From:	Linda Jordan <imjordan28@aol.com></imjordan28@aol.com>
Sent:	Monday, June 7, 2021 9:43 AM
To:	St. Germain, Dante
Subject:	Basin adjacent to land development PDS Case 21-ZONEPA-0032
Follow Up Flag:	Follow up
Flag Status:	Flagged

From:	Linda Jordan <lmjordan28@aol.com></lmjordan28@aol.com>
Sent:	Monday, April 12, 2021 9:51 AM
To:	St. Germain, Dante
Cc:	Linda
Subject:	Case No. 21-ZONEPA-0032 Development of 5661 W. Indian Trail
Follow Up Flag:	Follow up
Flag Status:	Flagged

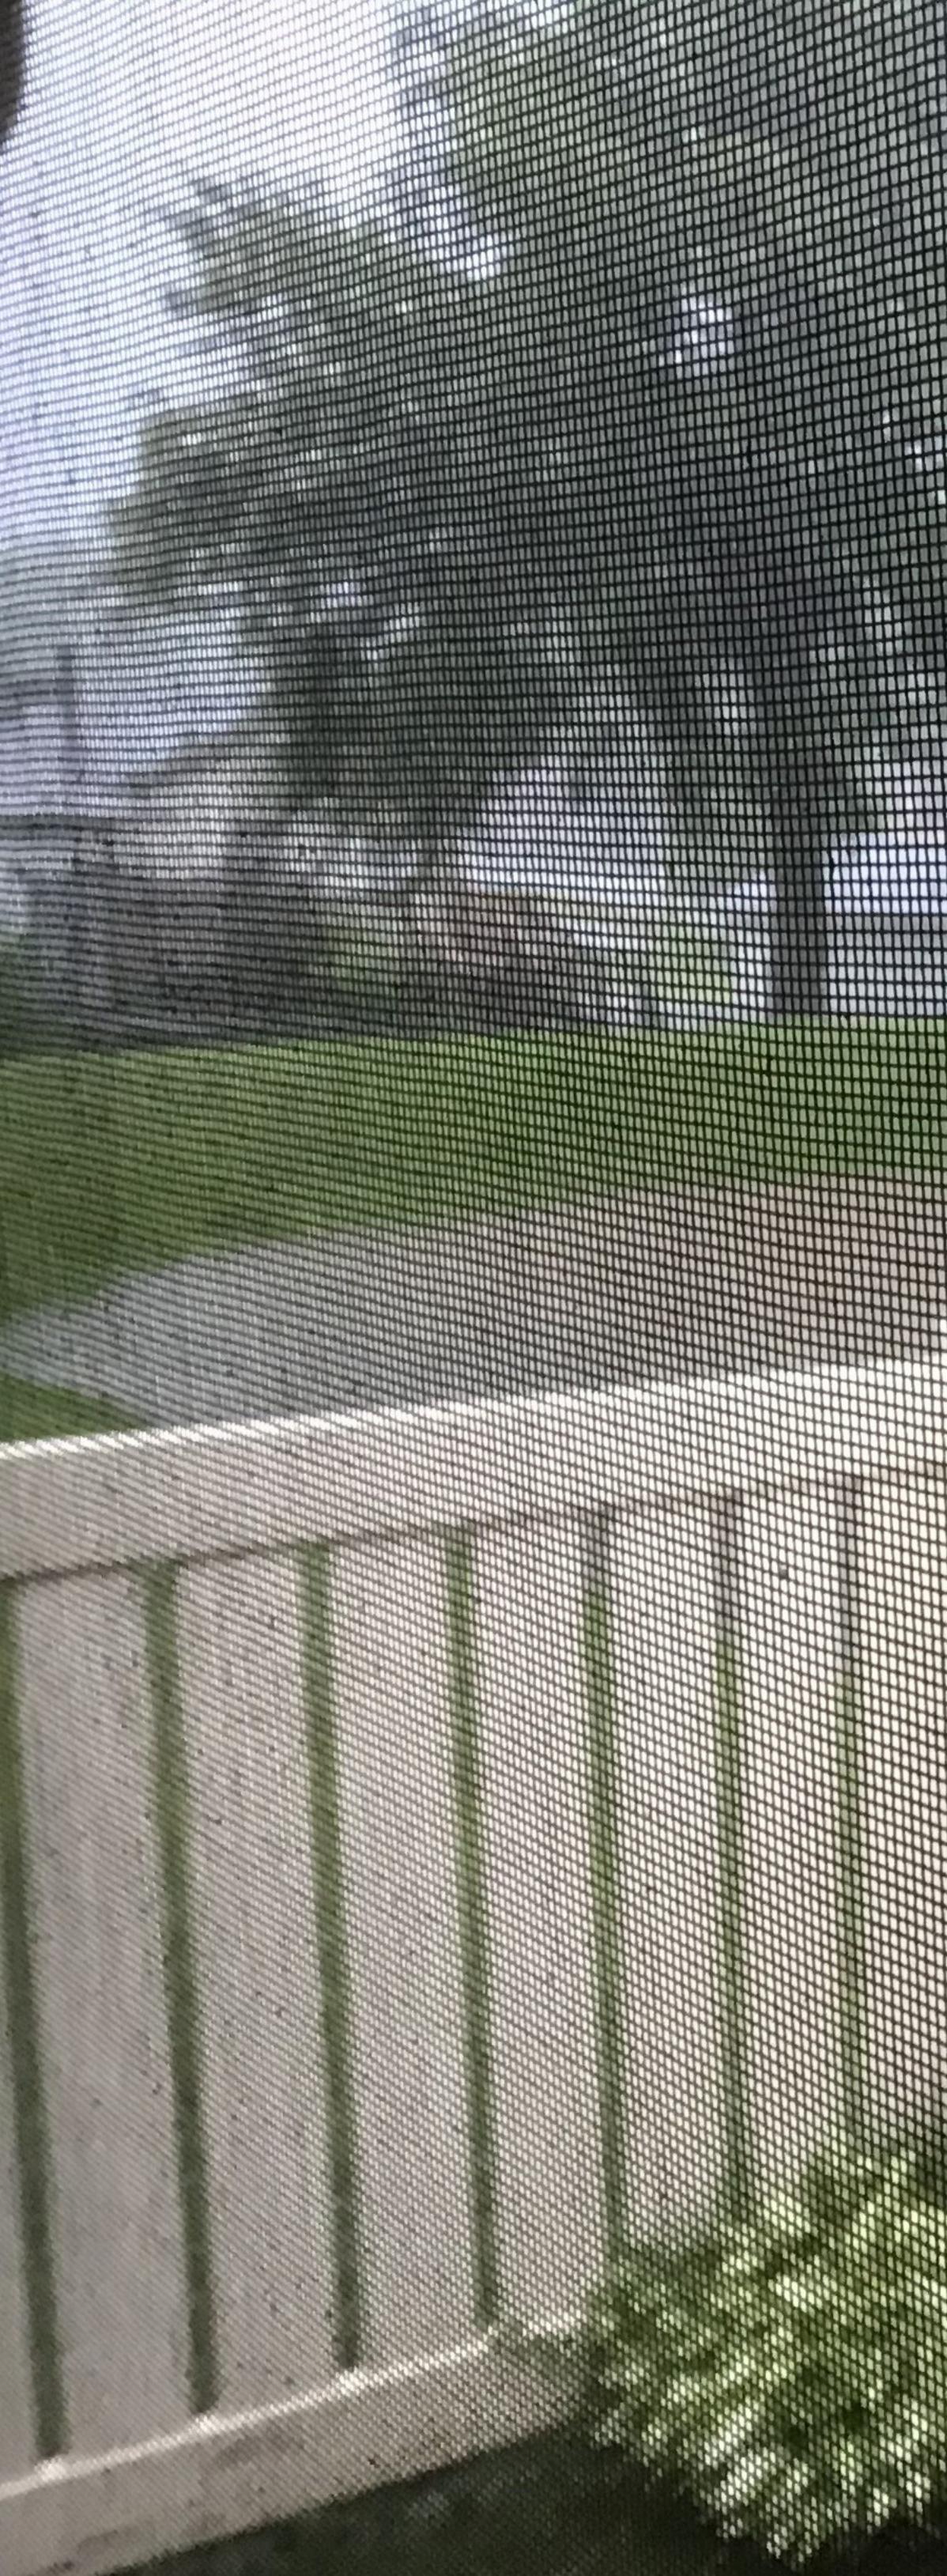
Attached are photos from the rain we experienced last Thursday, June 3, 2021. As I expressed to you in our telephone conversation a few weeks ago, I'm still concerned with the development of the adjacent property to my residence because this basin filled quickly with one inch of rainfall and then took well over an Hour to drop. During this time, my two sump pumps ran constantly. With the development of these properties, with all the additional drainage from the street once completed will slow the drainage from our basin.
